RE: RESPONSE TO SUBMISSIONS - MODIFICATION 5 TO EDMONDSON PARK CONCEPT PLAN (MP 10_0118) AND SEPP AMENDMENT

PROPERTY AT: GALLIPOLI DRIVE, BEZENTIN RIDGE ROAD, SOLDIERS PARADE AND CAMPBELLTOWN ROAD (LOT 1 DP1257105, LOT 2 DP1257105, LOT 3 DP1257105, LOT 4600 DP1248502, LOT 8 DP1200987, LOT 215 DP1186108, LOT 9 DP1220978, PART OF LOT 21 DP1238608 AND PART OF LOT 20 DP1238608)

Table 1. Response Matrix

Figure 1: Pedestrian Connectivity (Roberts Day, 2020)

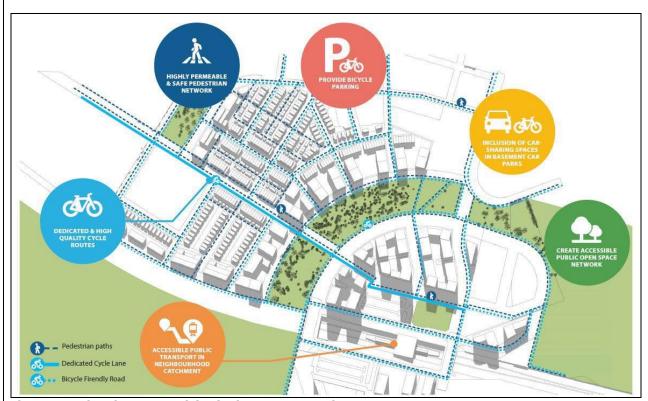
High density development should have access to a local-neighbourhood level park within a 200m radius, a district level park within a 1.2km radius (10-15 min walkability or a driving time of 4-6 min) and a regional park (active and passive) is required to be within a 2 km radius (25 minutes' walk) of dwellings.

The SIA report did not consider the quantity benchmarking as identified in Council's Recreation, Open Space and Sport Strategy (ROSS). It makes references to the NSW Government Architect's (GA) Draft Open Space Guidelines. The Government Architects 'Draft Greener Places Design Guide' is a draft document which does not give enough evidence to move away from required quantum of open space in Councils opinion.

It should also be noted that Clermont Park in Edmondson Park Town Centre North does not provide for a diversity in recreation spaces. Clermont Park can only accommodate two families at the children's playground at a time. The qualitative characteristics for Clermont Park is very low. The projected population of 7,065 also triggers a provision of 2 sporting fields (1Ha of sporting fields and courts per 1000 population - Government Architect's Draft Greener Places Guidelines).

Council staff recommends that in absence of a guideline to determine the quantum of open space provision in greenfield developments and in reference to Table 1 above, that a provision of 10 sqm/person for the development i.e. 7.07ha, instead of the proposed 5.9ha of open space within the Town Centre North.

The Edmondson Park Town Centre North includes a total of **5.9ha of public open space** which includes **4.3ha of public open space for conservation, 1.5ha of local open space and 0.1ha of green through site links**. In addition to the public open space, 3.7ha of private/strata open space is proposed and 2.9ha of low density private open space.

In addition, the broader Edmondson Park Concept Plan also provides a significant surplus of open space that will be available for future residents, including 150ha of regional open space and a 50ha network of smaller community parks, playgrounds, playing fields and reserves.

Importantly, Landcom will ensure a walkable neighbourhood is delivered with a focus on pedestrian and cycle paths which provide a high level of connectivity to the public open space networks (see **Figure 1**). Landcom are also committed to delivering high quality open space and examples of this are included below and are in addition to around 6.7ha of sport playing fields to be delivered by Landcom in Precinct 3, which is in the early design stages and negotiation with Council:

- Bardia Park 0.5ha local park
- Brigade Park 1.2ha local park
- Clermont Park 1ha local park
- Memorial Forest Reserve 1ha Dog park plus 2ha open space
- Mont. St. Quentin Oval 5.4ha Sport Facility and inclusive play ground
